Subject: MHI's Responses to US-APWR DCD RAI No. 212-1950

Responses to Request for Additional Information No. 212-1950,
Revision 1

**US-APWR Design Certification
Mitsubishi Heavy Industries
Docket No. 52-021**

RAI NO.: NO. 212-1950 REVISION 1
SRP SECTION: 03.07.02 – Seismic System Analysis
APPLICATION SECTION: 03.07.02
DATE OF RAI ISSUE: 02/25/09

Fig.19.1 Fixed-Base FE Model of R/B

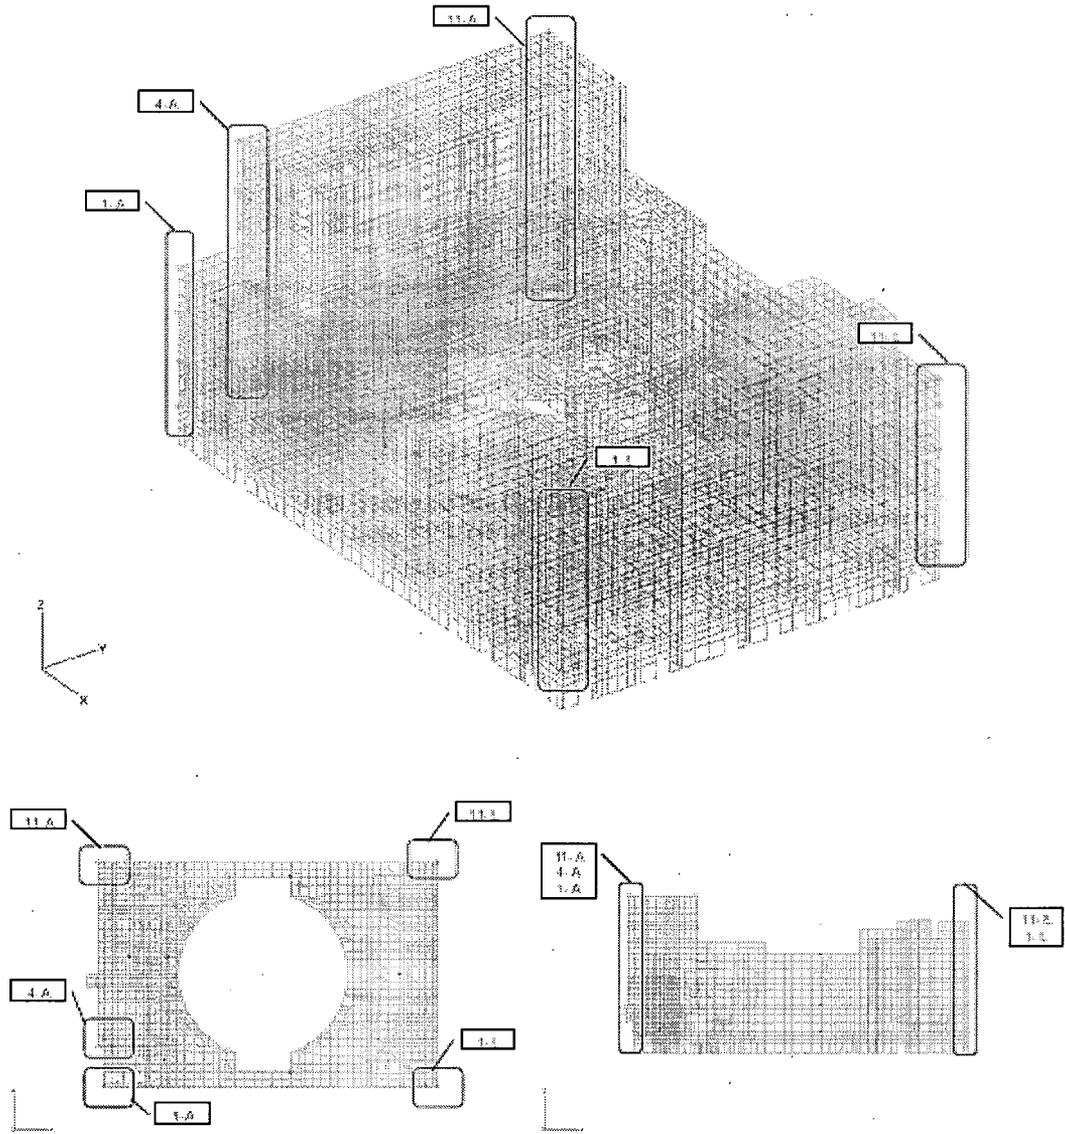
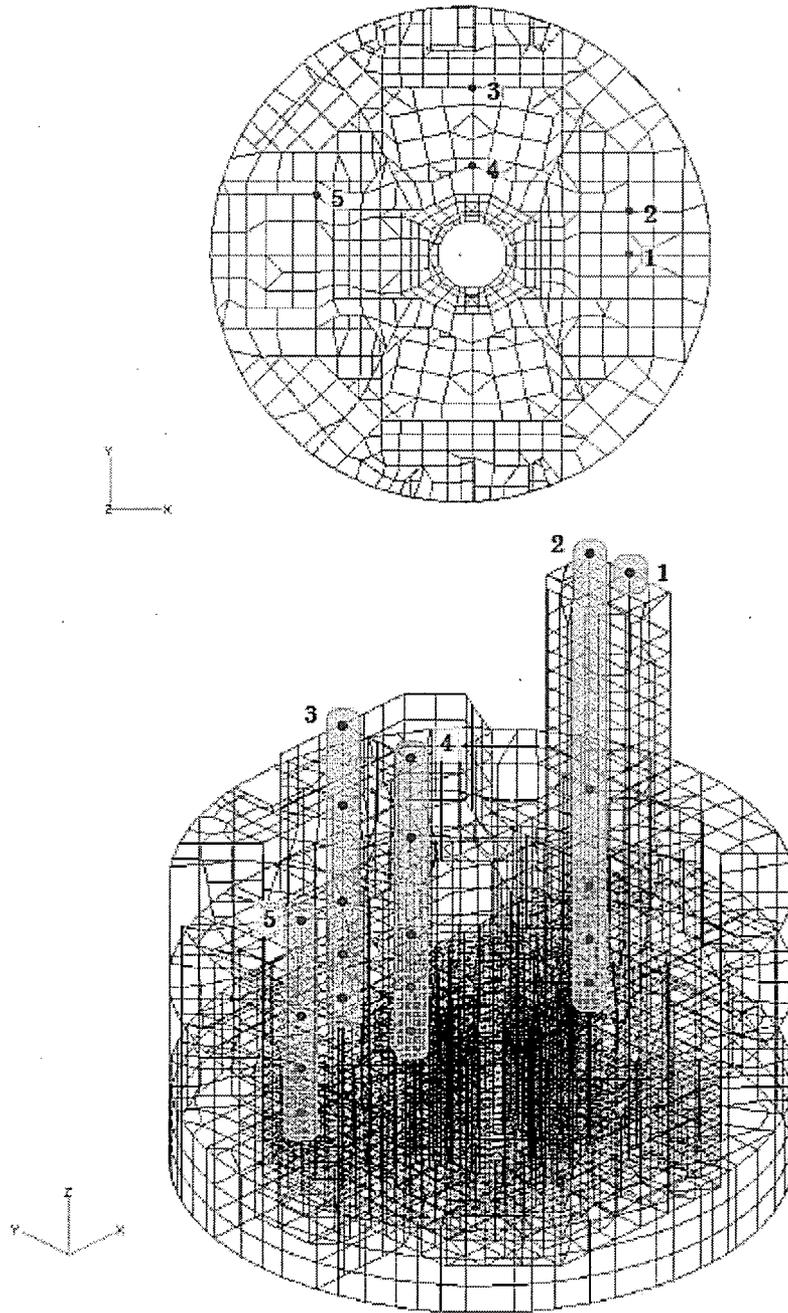
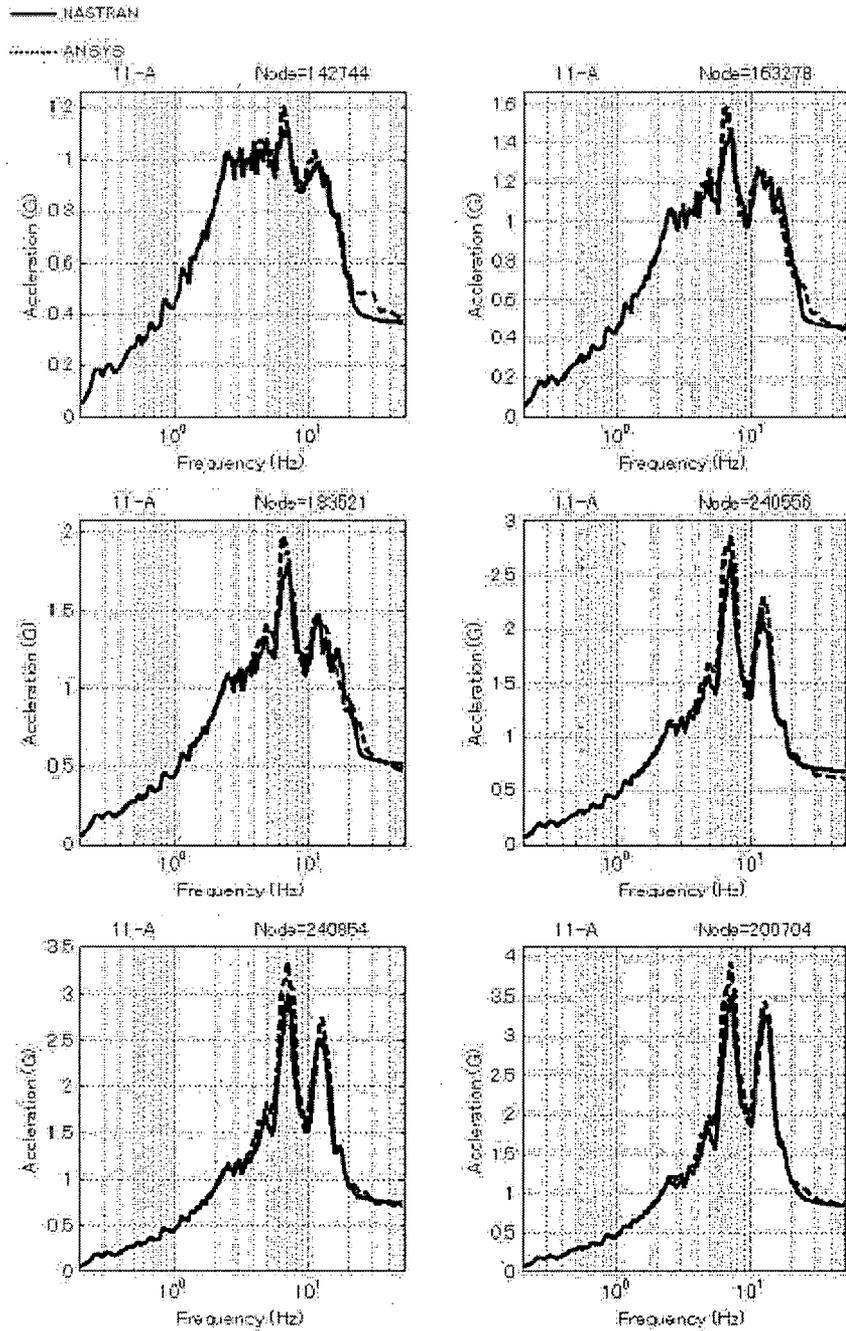
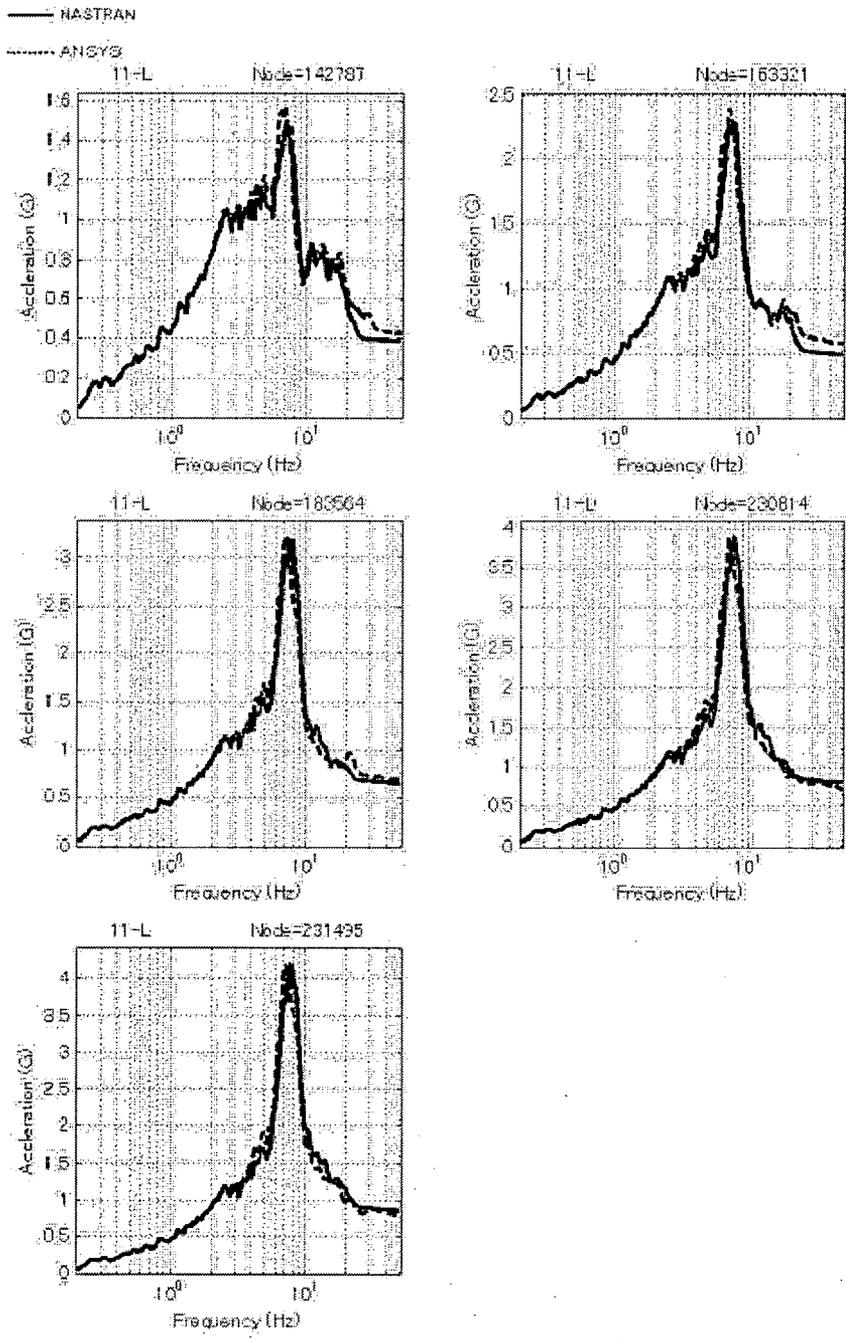
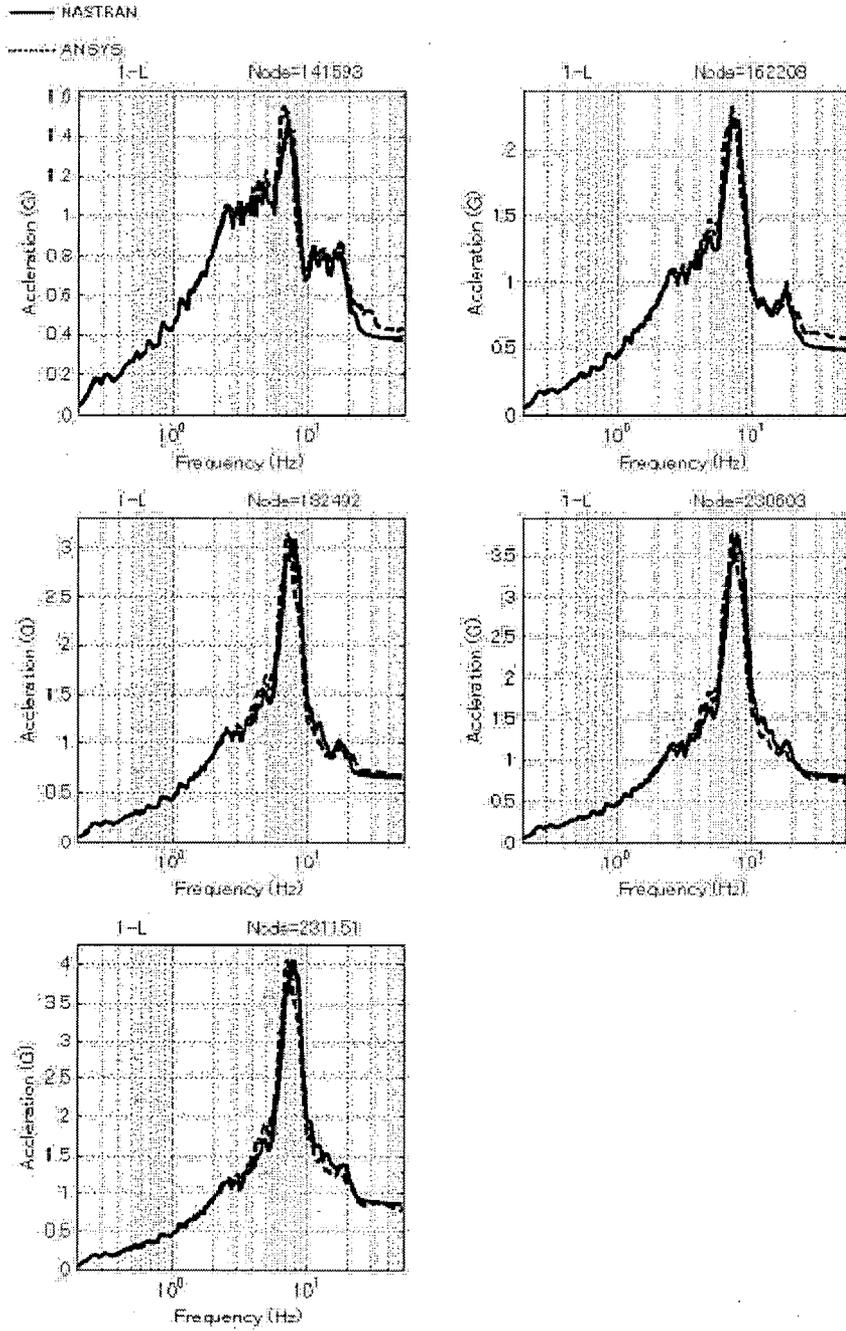
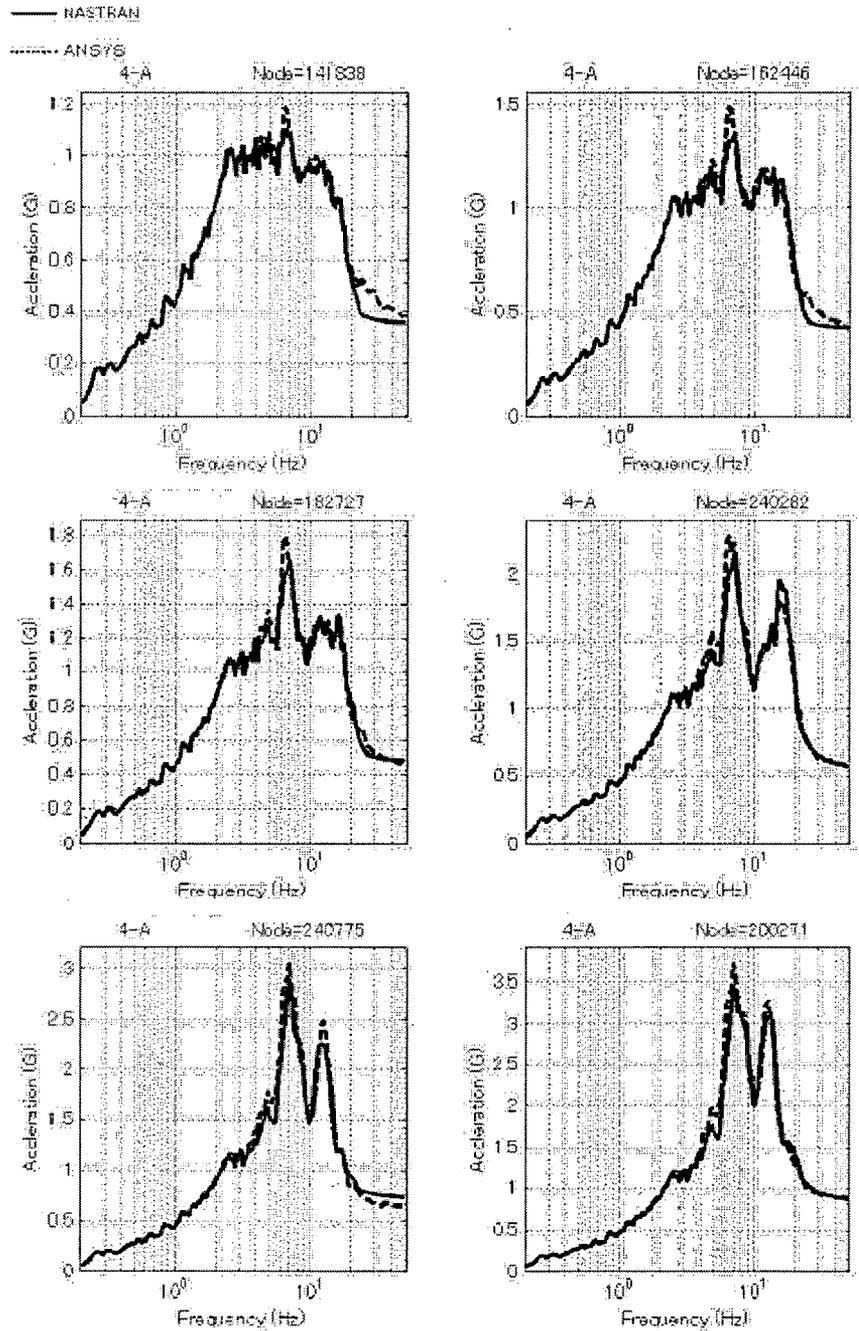
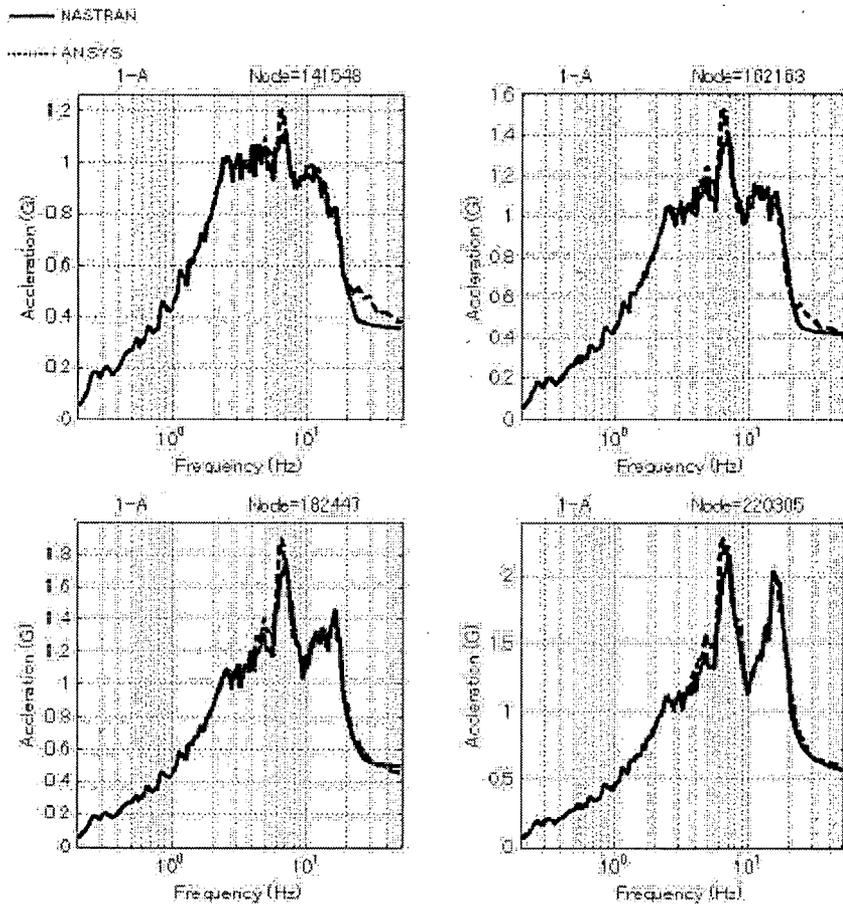
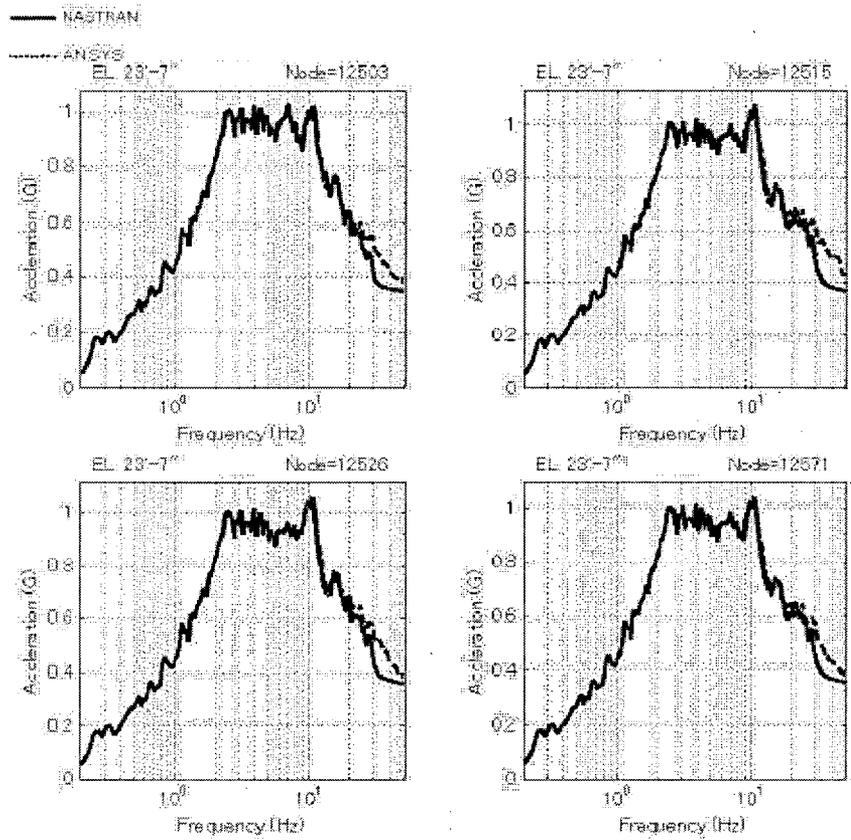
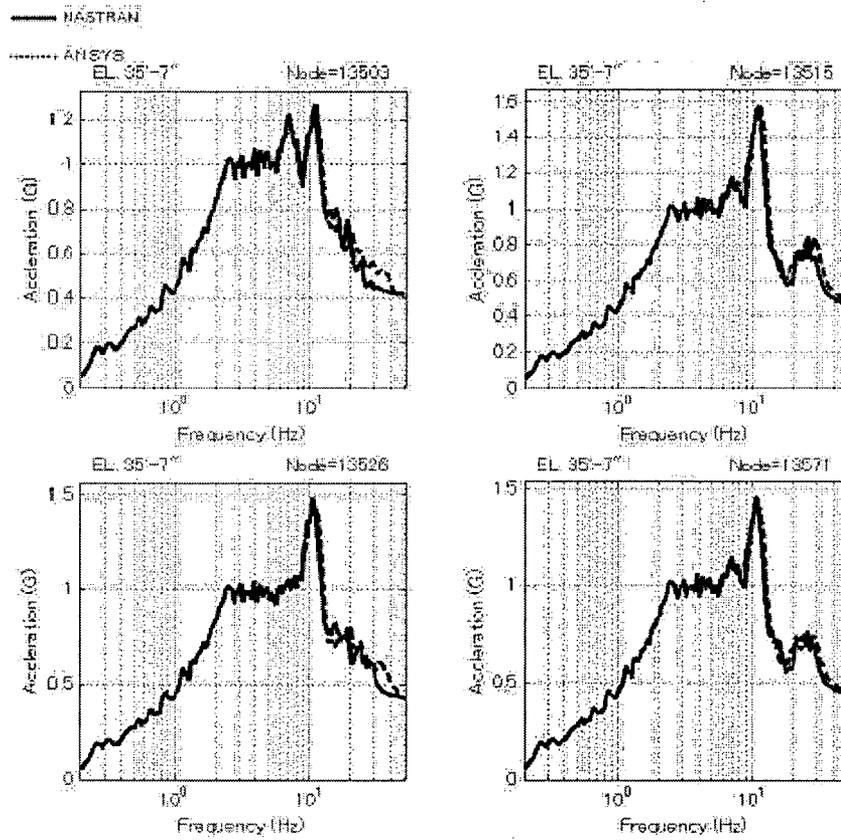
In Section 3.7.2.3.1 of the DCD it is stated that the NASTRAN finite element models are used for validation of the dynamic lumped mass stick models and the NASTRAN results are validated by comparison to the results of separate ANSYS finite element model analyses. Provide results and details of the NASTRAN and ANSYS validations. Describe how the various finite element models that were developed for validation meet the guidelines of SRP Sections 3.7.2.II.3.C.ii and iii.

To verify whether the dynamic properties of the NASTRAN FE model conform to those of the ANSYS FE model, the 5% damping ISRS are calculated at several node points in both models that represent main floor levels. The points selected for validation are shown in Figures 19.1 and 19.2 (below) and Tables 19.1 and 19.2 (below) which are the same points selected in Subsection 3.7.2.3.10 of the DCD.

As stated in the response to question RAI 3.7.2-8 of this RAI, ISRS which incorporate the effects of local vibration modes will be provided in Revision 2 of the DCD. The revision will meet the guidelines of SRP Section 3.7.2.II.3.C.iii.

Further results and details of NASTRAN and ANSYS FE model validations will be provided in Revision 2 of the DCD. The response previously submitted for RAI 212-1950, Question RAI 3.7.2-8, states the ISRS, considering local vibration modes, will be provided in Revision 2 of the DCD.
